## FORD E4OD "UPDATE HANDBOOK"

### INDEX

Figure 11  
AUTOMATIC TRANSMISSION SERVICE GROUP

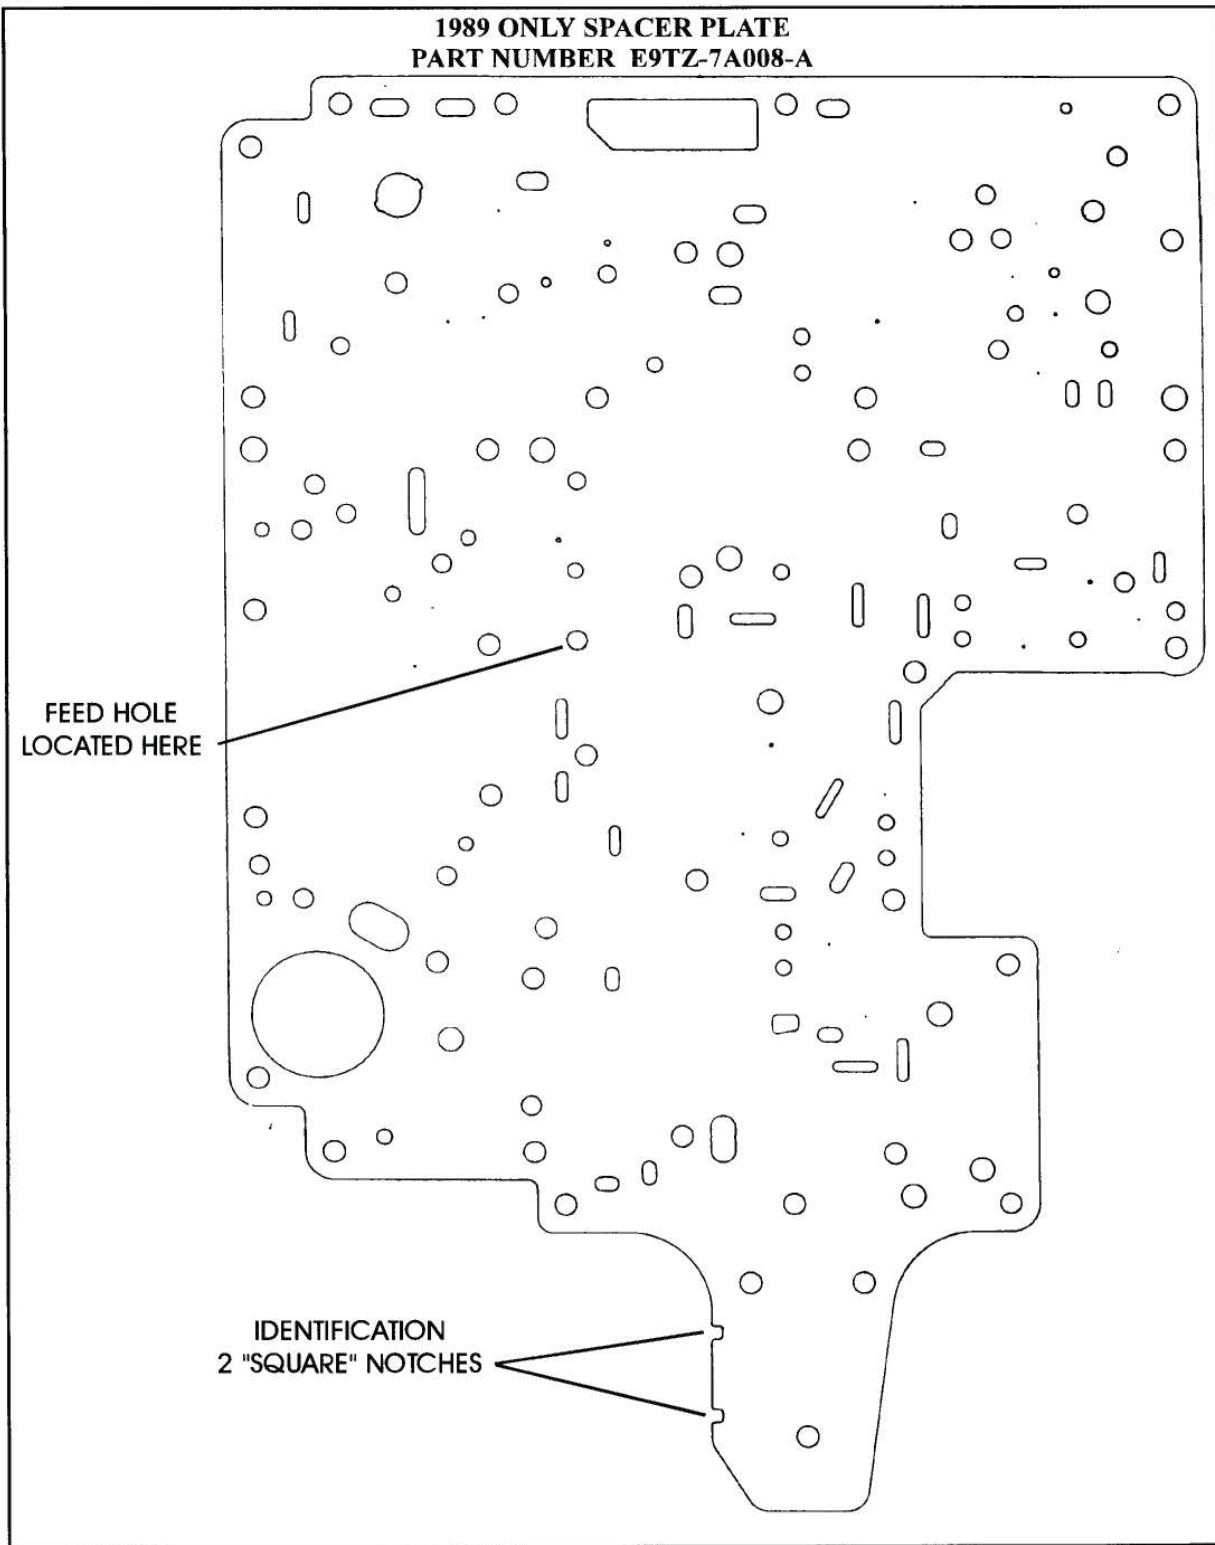
- (4) **MAIN VALVE BODY SPACER PLATE**- Has changed twice since the introduction in 1989.  
*1989 Models Only* - Requires the Spacer Plate with the solenoid feed hole in the location shown in Figure 11, and has two "Square" notches for identification

Figure 12

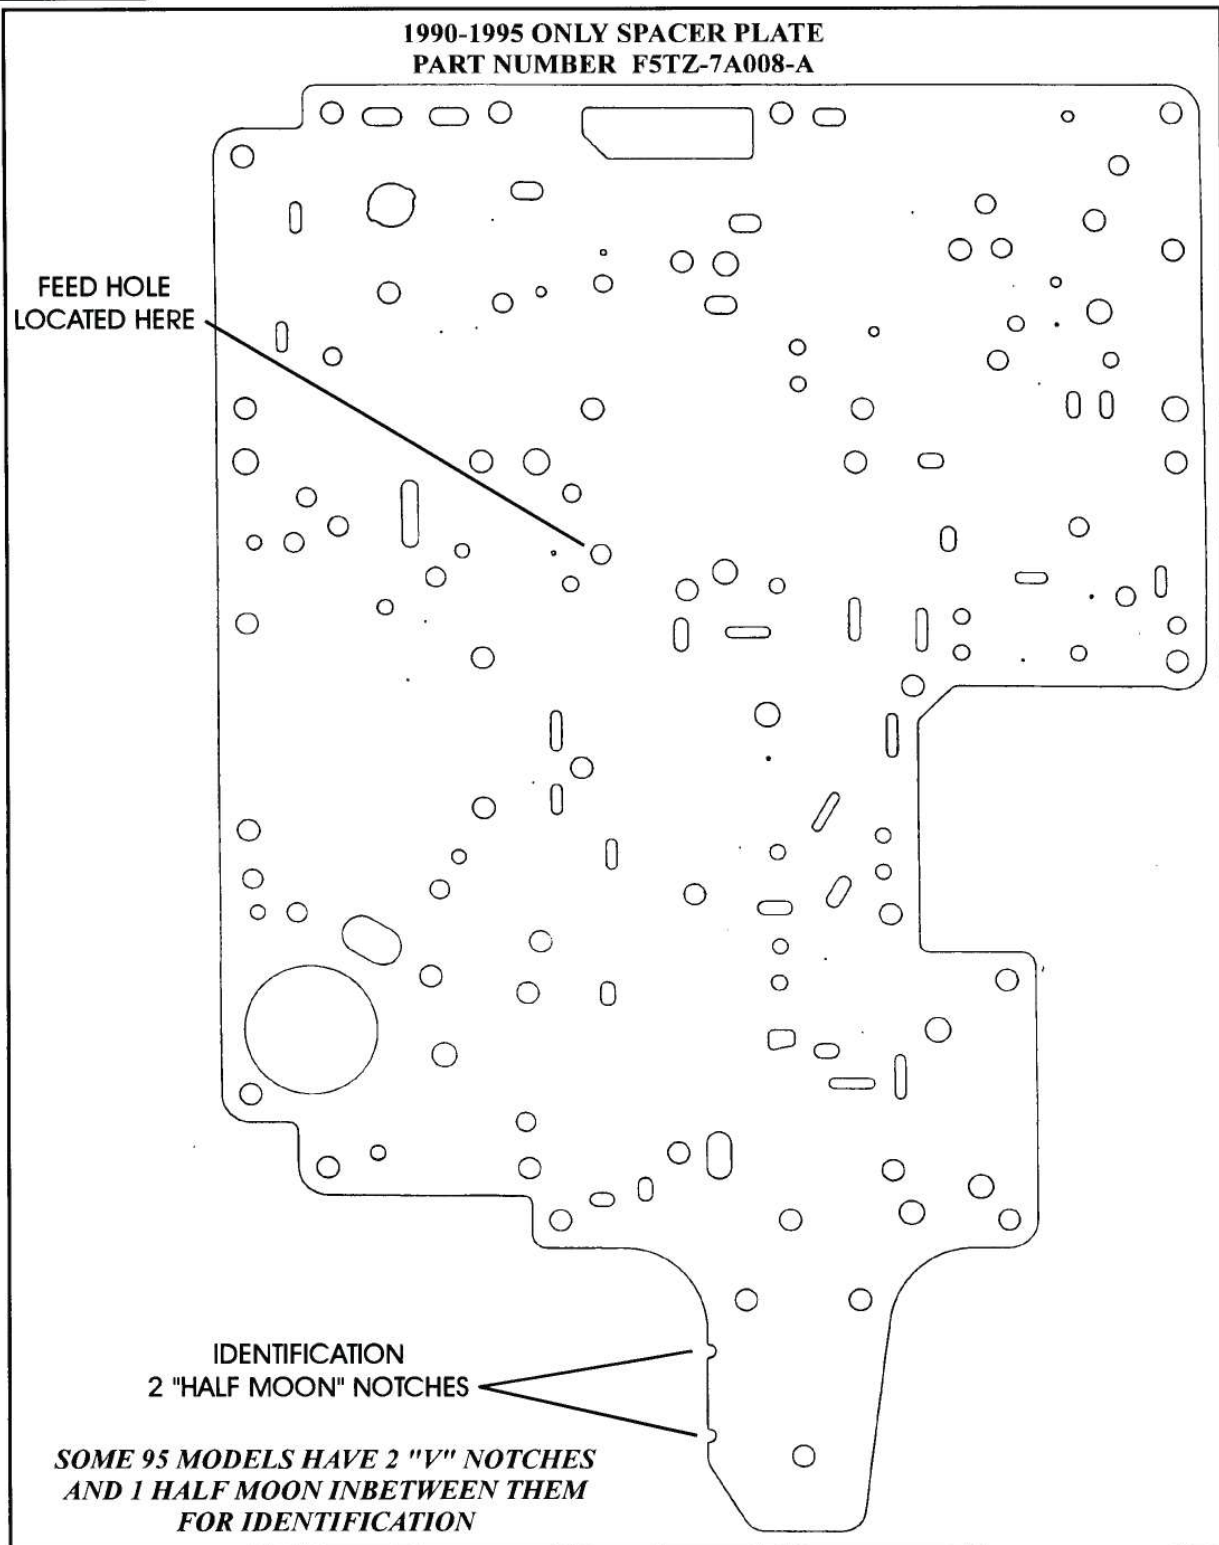
*90-95 Models Only* - Requires the Spacer Plate with the solenoid feed hole in the location shown in Figure 12, and has two "Half Moon" notches for identification. Note; Some models have two "V" notches with one "Half Moon" notch between them for identification.

Figure 13

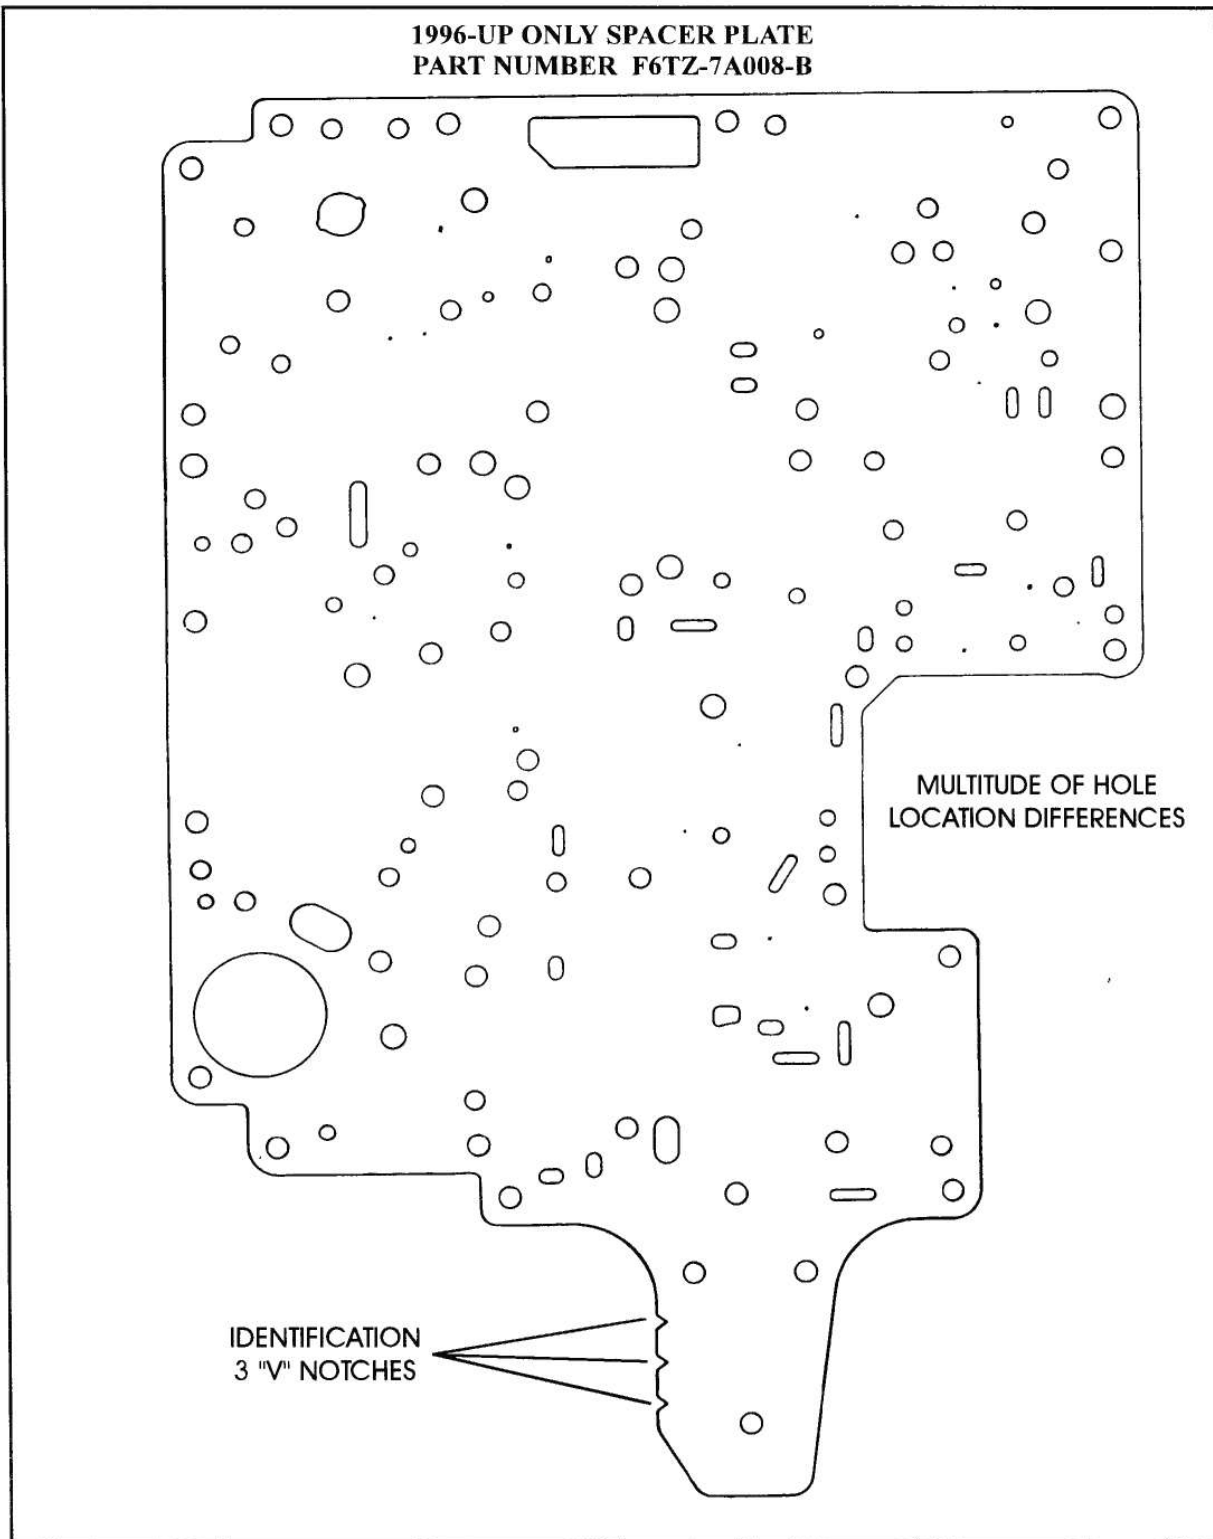
*1996-UP Models Only* - Requires the Spacer Plate with the three "V" notches for identification as shown in Figure 13, and has a multitude of hole location changes.
- (5) **MAIN VALVE BODY** - Has changed twice since the introduction in 1989 as listed below.  
*1989 Models Only* - Can be identified by the differences in the worm track area at the 1-2 shift valve, as shown inside the circles in Figure 14. The best, and most accurate method to identify the valve body, is the rough forging number cast into the valve body in the location shown in Figures 1 and 2.

Figure 14

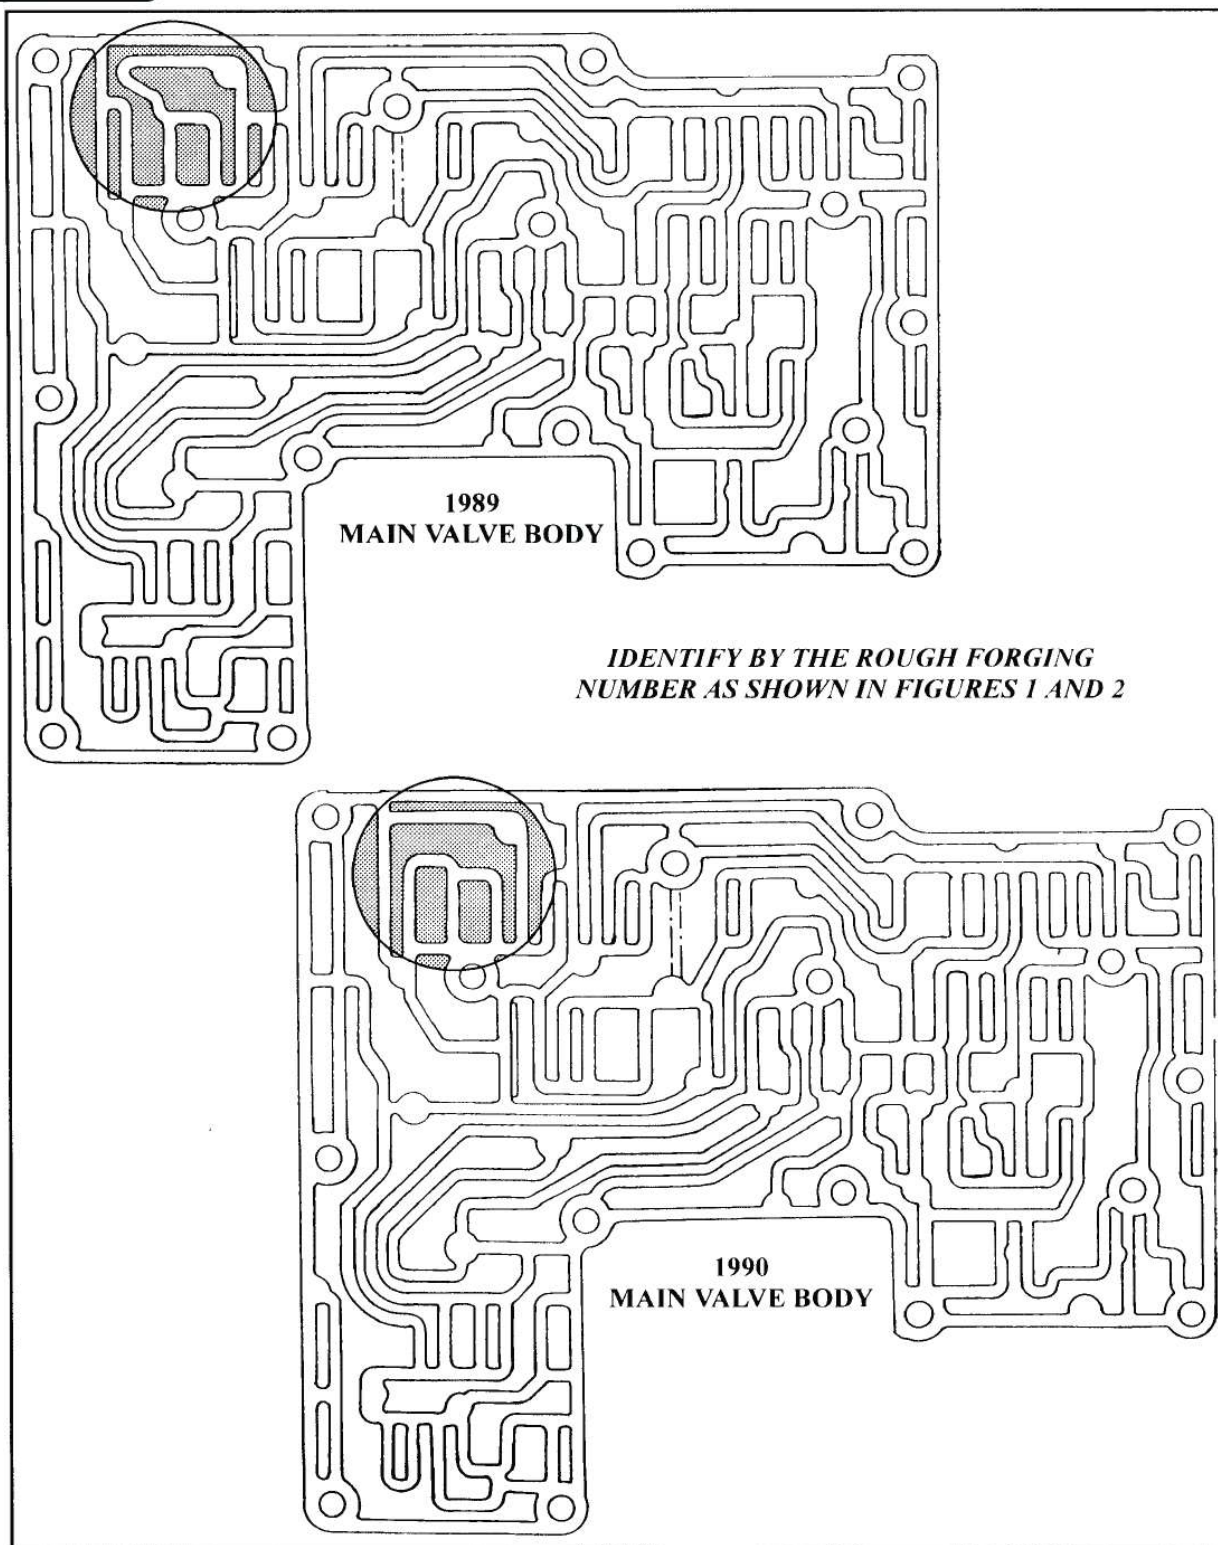
*90-95 Models Only* - Can be identified by the differences in the worm track area at the 1-2 shift valve, as shown inside the circles in Figure 14. The best, and most accurate method to identify the valve body, is the rough forging number cast into the valve body in the location shown in Figures 1 and 2.

Figure 16

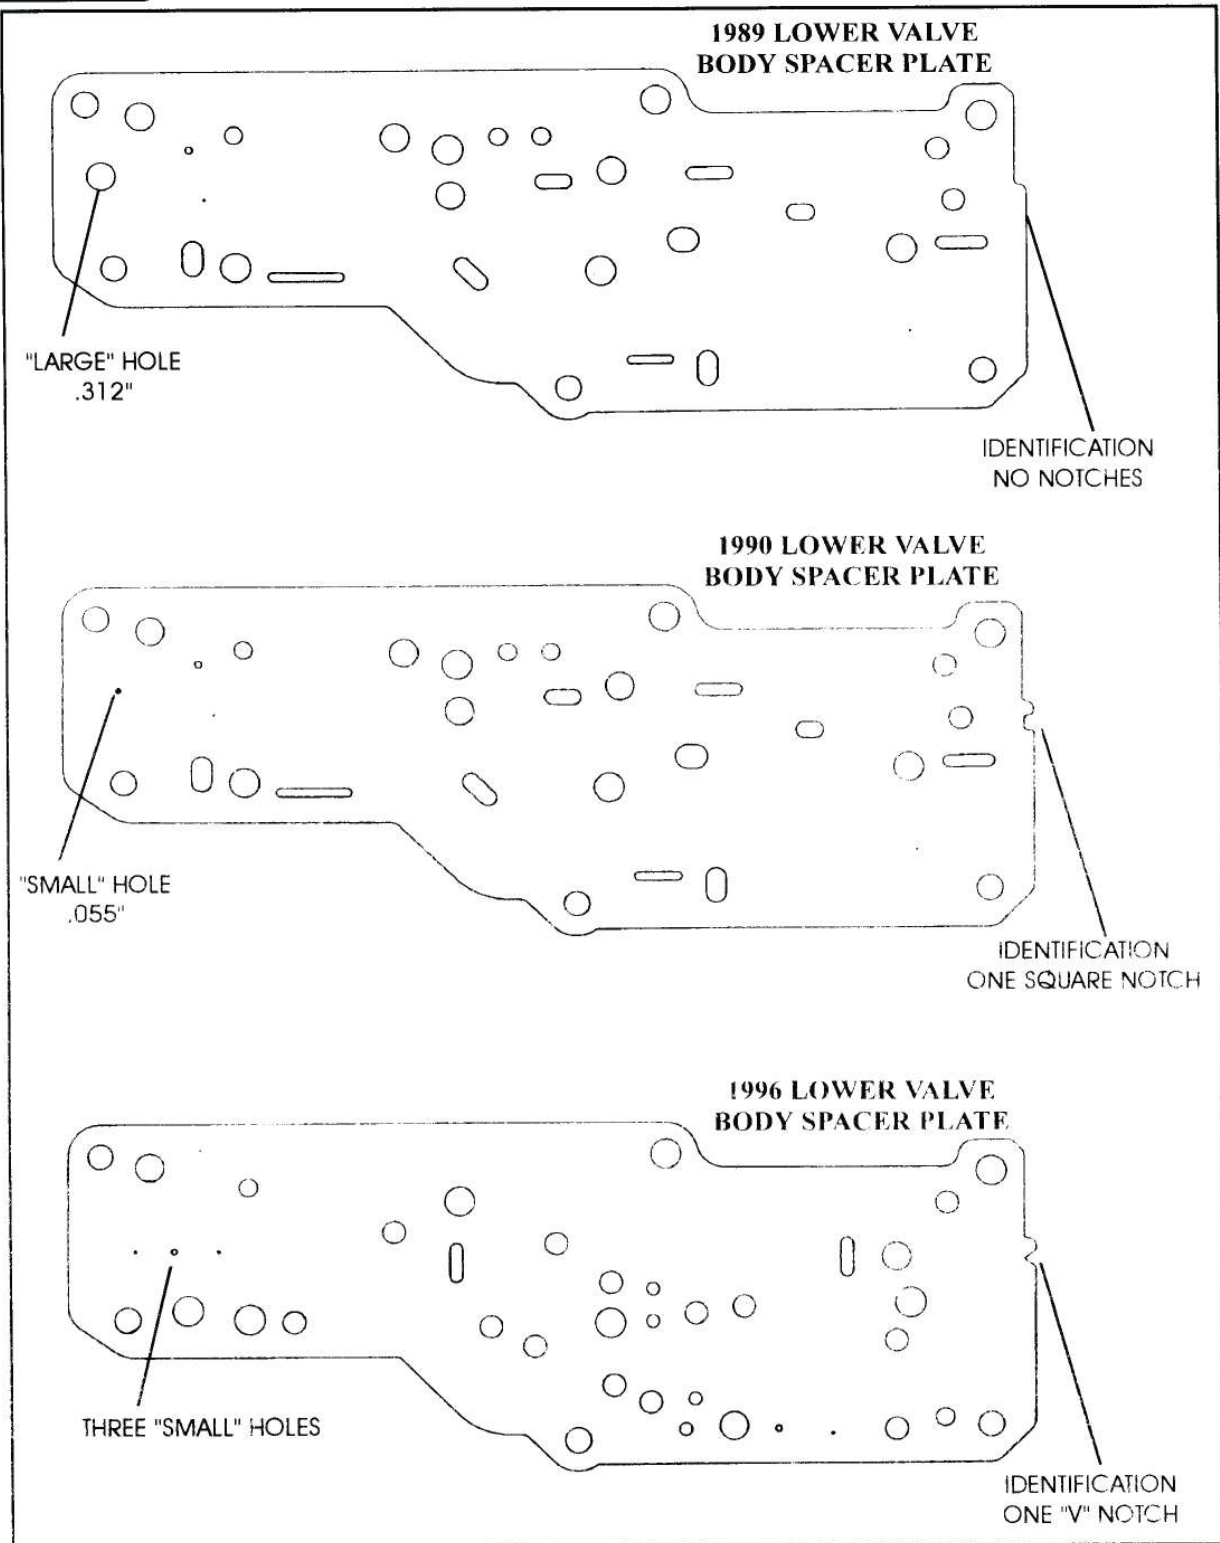
- (6) **LOWER VALVE BODY SPACER PLATE** - Can be identified by the diameter of the feed hole in the location shown in Figure 16. For 1989 models the hole diameter is .312", and for 90-95 models the hole diameter is .055".  
The 1996-Up models have three small holes in this location, as shown in Figure 16, and a multitude of hole location differences to accommodate the added valve body checkballs.
